Access Compliance Report

Public Rights-of-Way

Intersection ID: 7100	Main Street: MOTORSPORTS_LN	Cross Street: STATESVILLE_RD	Location: SW
ADA ID: C7C0C3936E15	Ramp Type: Para	Initial Pass/Fail: Pass	Overall Compliance: No
Codes/Mitigation Info/Possible Solution		Field Measurements/Component Compliance

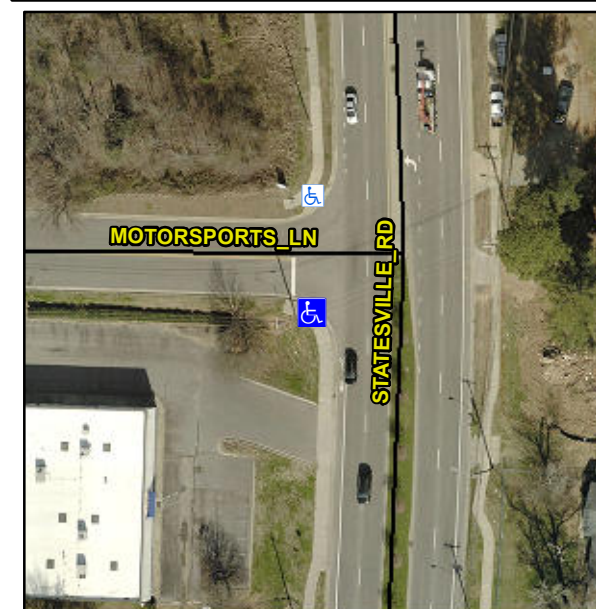
NO RT SW, RT RP < 5%

R304.5.3, R305.2, R302.7, R304.5.4

Remove & Replace Entire Ramp.
Remove & Replace Gutter.
